Western Everglades Restoration Project

Virtual Project Delivery Team Meeting and Listening Session

December 09, 2022

From 28 Feb 2022 PDT

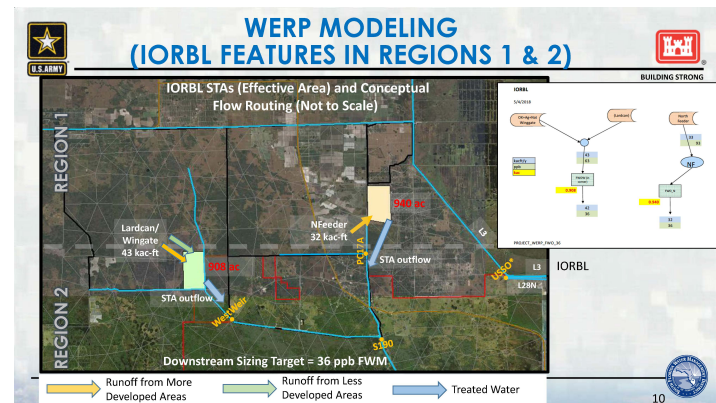
- Land and sizing issues with current proposed Wingate Mill STA.
 - Current stakeholder concerns
 - Concerns regarding ability to effectively operate (maintain target stages).

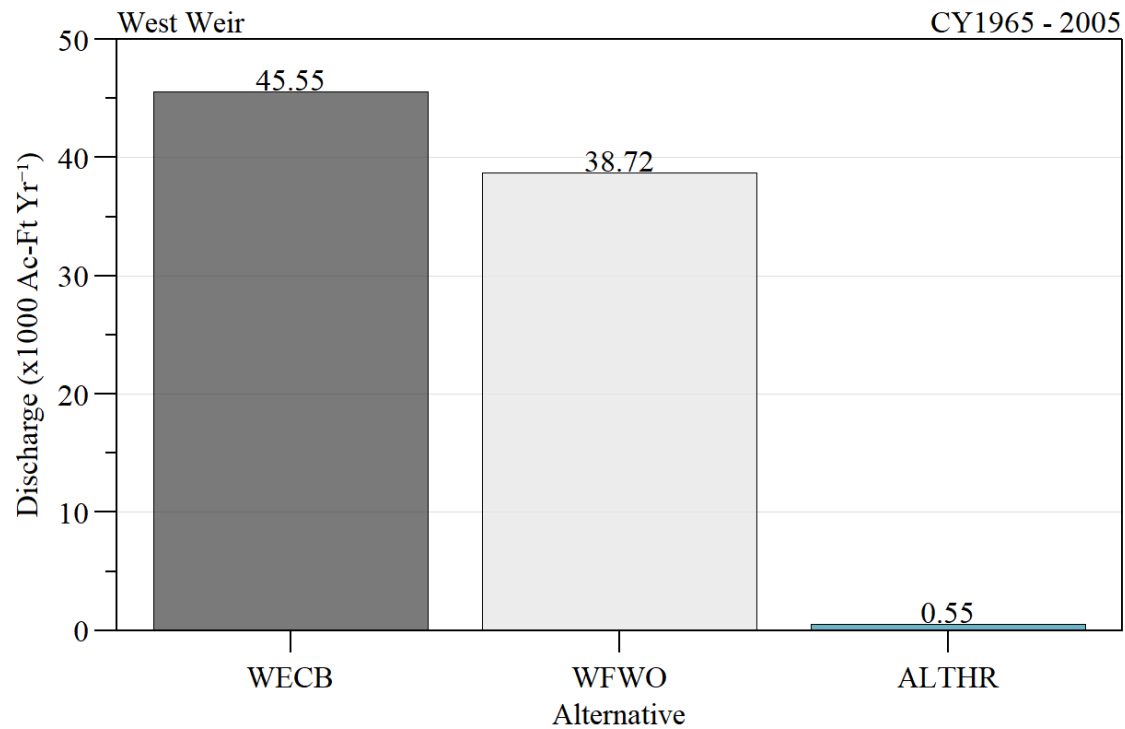
- Costly to run (i.e. pumps, flocculent, etc) and maintain (i.e. drying and disposal of flocculent material)
- Must understand water chemistry to optimize treatment without exporting flocculent material (i.e. sulfate, aluminum, etc.)
- Regional concern regarding mercury methylation (and other ecological and biogeochemical effects) due to increases sulfate load
- If treatment is not optimized, particulate aluminum (if Alum is used) can be discharged and cause downstream pH specific toxicity concerns
- Arsenic accumulation in biotia
- Still requires land

Based on evaluation of past and ongoing pilot projects, the **cons** outweighs the pros for HWTT or chemical treatment and therefore it is **NOT** supported/recommended by SCCF and CoSWFL.
